New
Product

JUMPDOWN JUNCTIONS

An innovative solution to prevent stranding and backflow in drain lines

The Solution

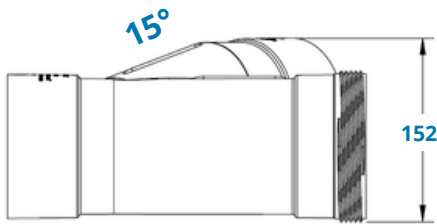
AS/NZS 3500.2 Clause 4.9.1.2 was updated such that branch lines coming into the main drain must be installed with at minimum 15° incline to ensure they are higher than the main sanitary line.

Modern drain lines face stranding and backflow issues due to the ever decreasing flow rates caused by the introduction of low flush WC's, efficient WELS rated tapware, waterless urinals and other water saving technologies.

Branch lines coming into the main drain must be installed with a minimum incline of 15°.
